OICA Data Collection and initial response to JRC proposal

OICA Data on Friction Energy Share

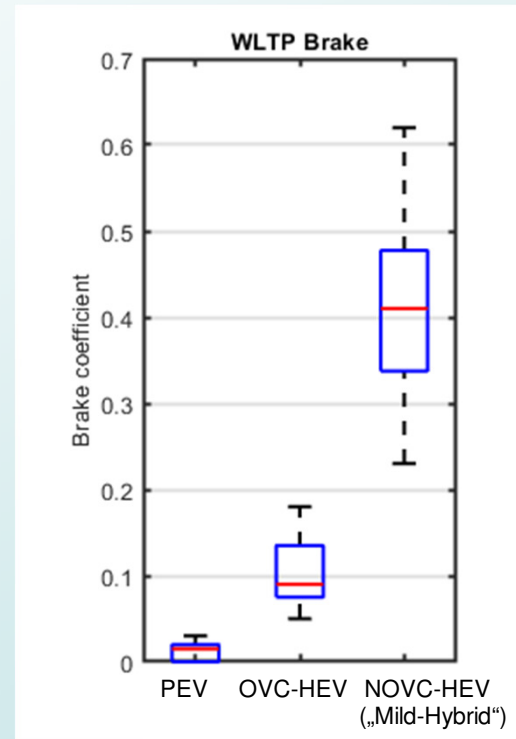
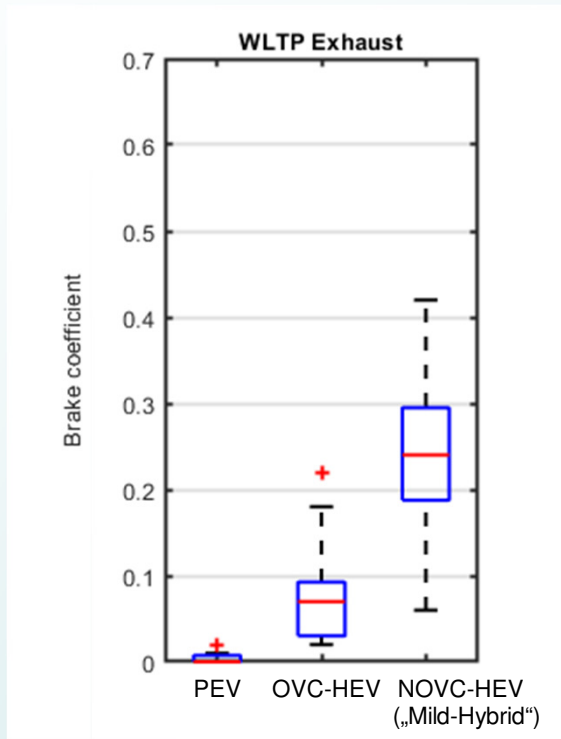
Initial Conclusions on Friction Energy Share

Vehicle Category	Observed Energy / Coefficient WLTP Brake median (range)	JRC's initial Coefficients
PEV	0.02 (0.0 - 0.03)	0.17 - 0.19
OVC-HEV	0.09 (0.05 - 0.18)	0.30 - 0.32
NOVC-HEV		
NOVC-HEV („Mild-Hybrid“)	(0.23 - 0.62)	0.60 - 0.65

- The observed ratio of WLTP Exhaust / WLTP Brake depends upon P/T concept
- The observed Friction Energy Share is substantially lower than initially suggested by JRC
- There is a large spread of Friction Energy Share – particularly for “mild-Hybrids”
- Individual vehicle specific Energy Shares are needed for JRC Procedure
